At Island Avenue, Cliff
Island-I

Subject: Permit for construction of one story
cottage 11' x 18' off Island Avenue, Cliff
Island

RESIDENCE ZONE - C
APPLICATION FOR PERMIT

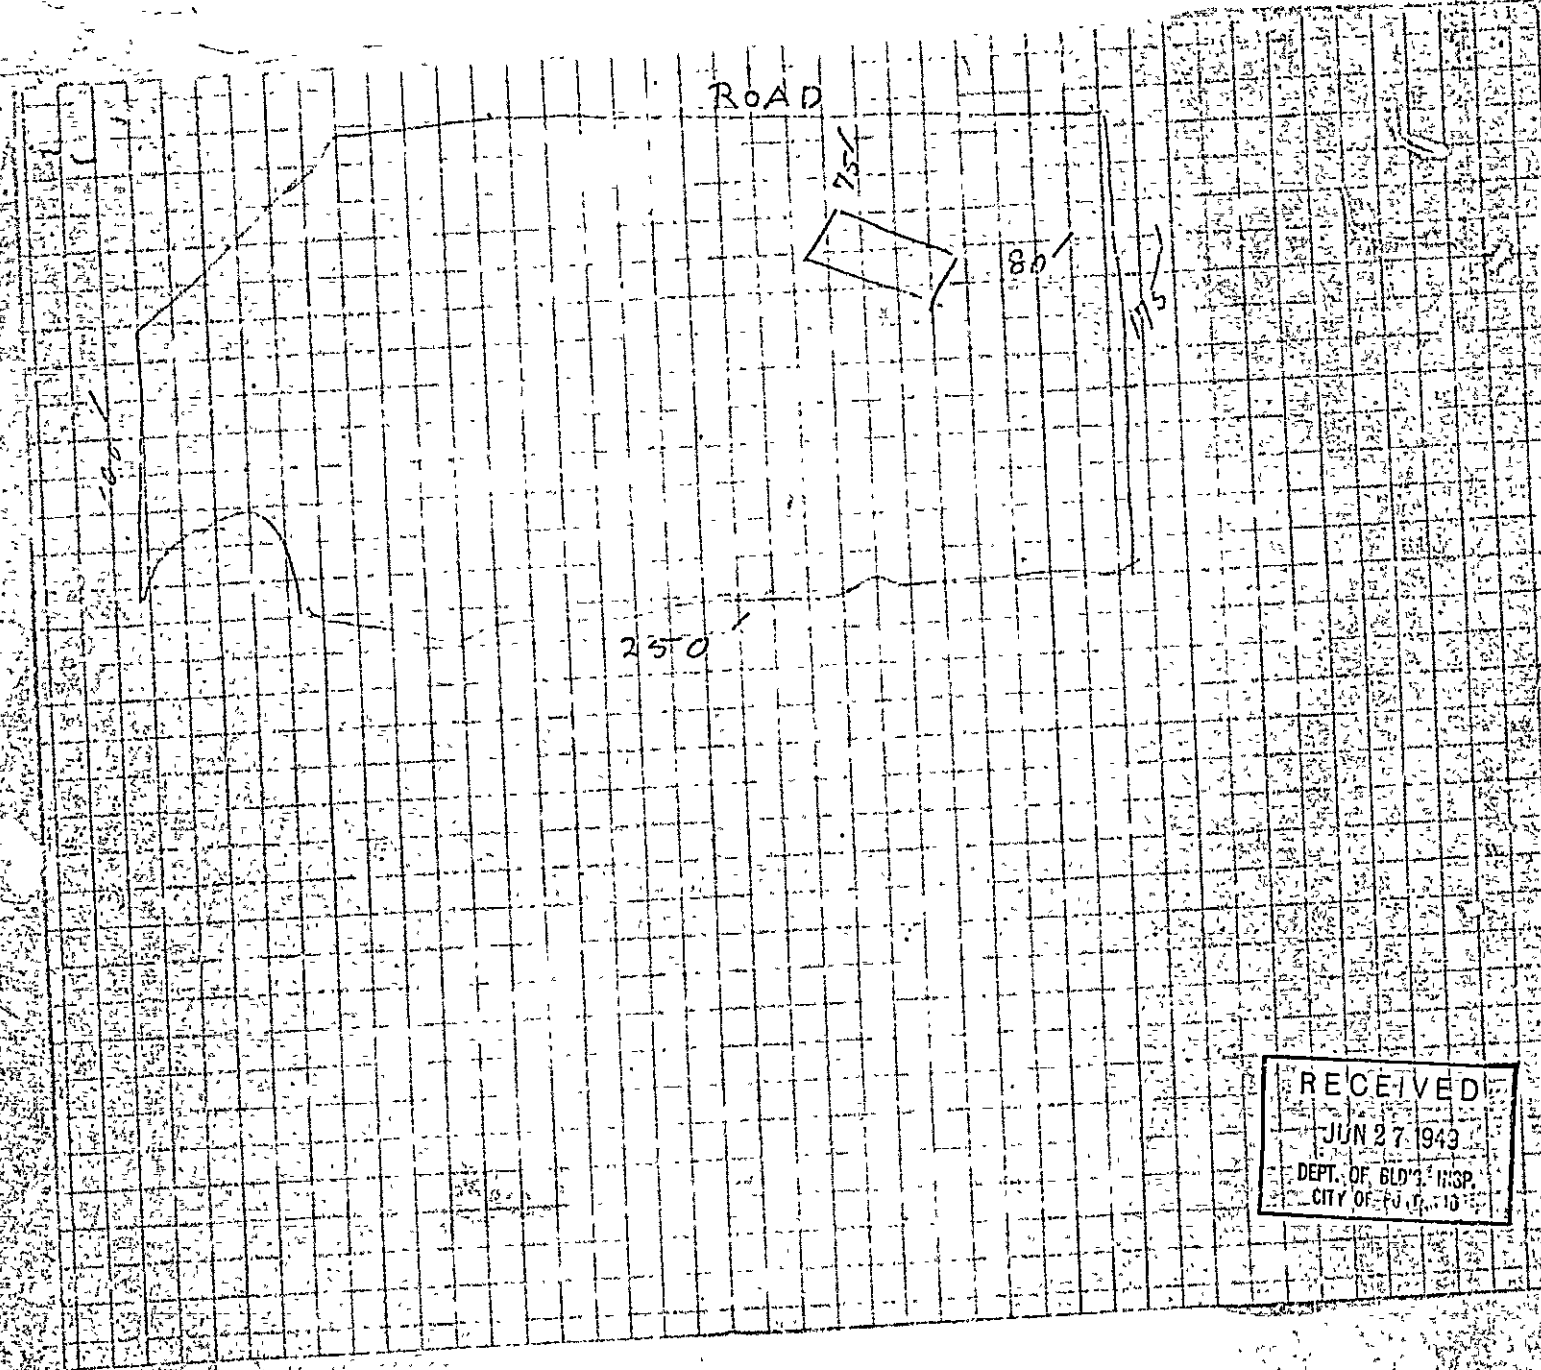
1. Spacing of piers for support of building is not shown. If the 6x8 sills as given in application are placed with the 8" dimension upright, piers will only be needed at the corners, at the halfway points on the long sides of the building and at each side of the opening where the fireplace is to be built. The permit is issued on this basis. If a different sill or other spacing of piers is contemplated, approval should be secured at this office before going ahead.

2. There is no indication as to how the 2x8 floor joists are to be supported on the sills. Unless they are to rest on top of the supporting member, they are required to be notched over no less than 2x3 nailing strips spiked to the sides of the sills.

3. No less than 1x6 cross bridging is required at the center of the span of the floor joists.

4. We understand that the piers supporting the building are to be of stone laid in cement mortar. If such is the case, they should not be less than twelve inches square and are required to extend to ledge or at least four feet below grade if ledge is not encountered at a lesser depth and to project at least 6" above the finished grade so that all parts of the sills will be 6" or more clear of the ground and will be kept that way.

5. While according to present plans only the foundation for the fireplace chimney is to be built right away, it is important that the opening in end wall be made wide enough to accommodate the chimney when it is built. Since stone is to be used in the construction of this chimney, a minimum thickness of 12" for walls of both fireplace and chimney is required. This should be taken into consideration in framing opening in wall of building. A permit will be needed before work on the chimney is started.

6. Studs in outside walls are required to be spaced no more than 24" on centers.

7. Presumably the oil stove indicated in application for heat in the building is one in which the height of the flame is controlled by raising and lowering of the wick. A masonry chimney is required if any other type of equipment using liquid or solid fuel is to be used.
